TR-9 Open Source Digital Radio

Sheet: /
File: HMI.sch

Title: HMI Board

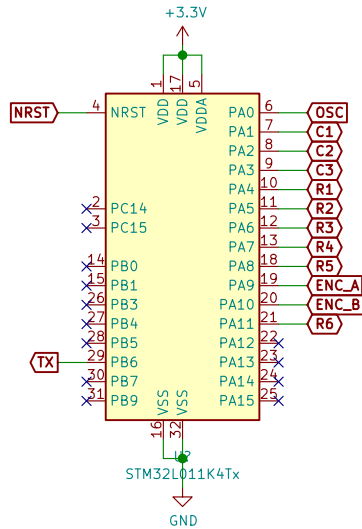
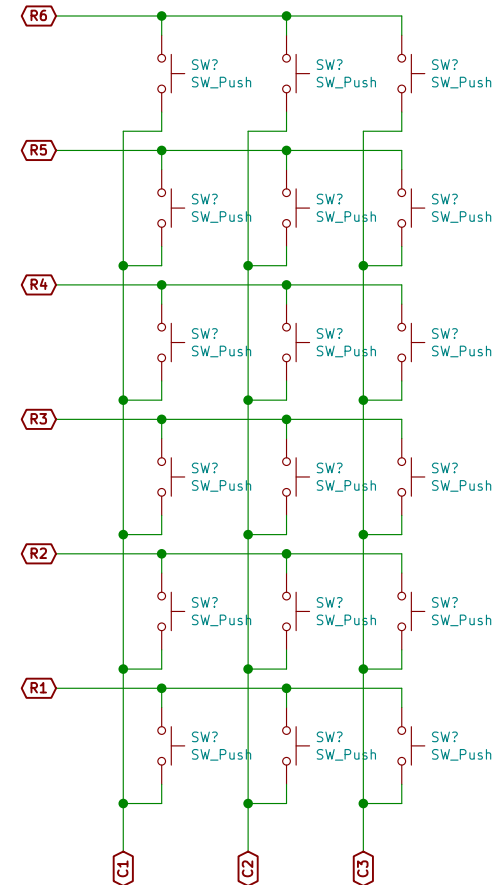
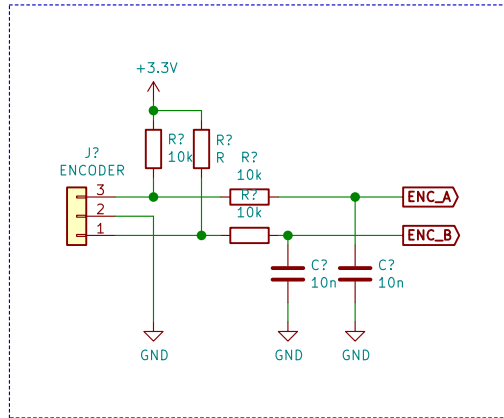
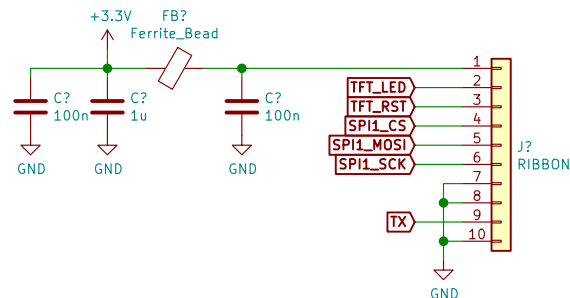
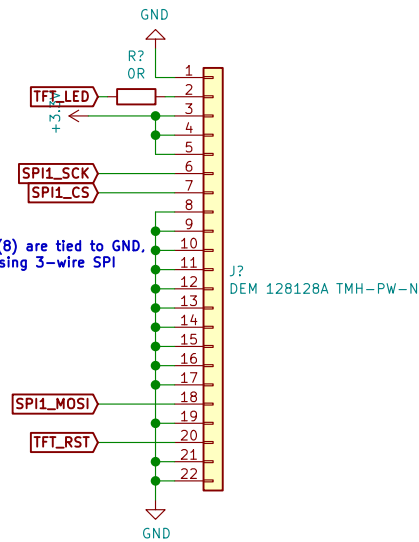
We are using a pot instead – so no longer needed

/RD (9) and /WR (8) are tied to GND, assuming we are using 3-wire SPI
